FRIDGE DOOR BLOCKED AFTER DOOR REVERSING; DOOR SHELF BROKEN.**DESCRIPTION:**

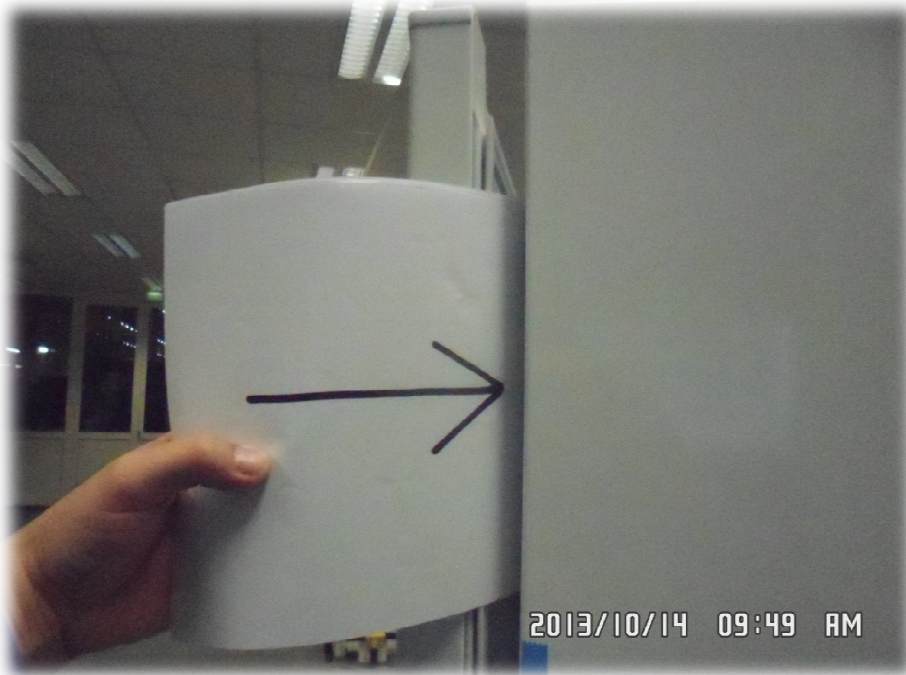
In some models due incompatible light switch shape fridge door might collide with butter shelf. Problem occurs after door reversing procedure.

Switch shape that can cause problems.

Shape of switch that will not cause problems.

To solve this problem it is necessary to exchange the light switch.
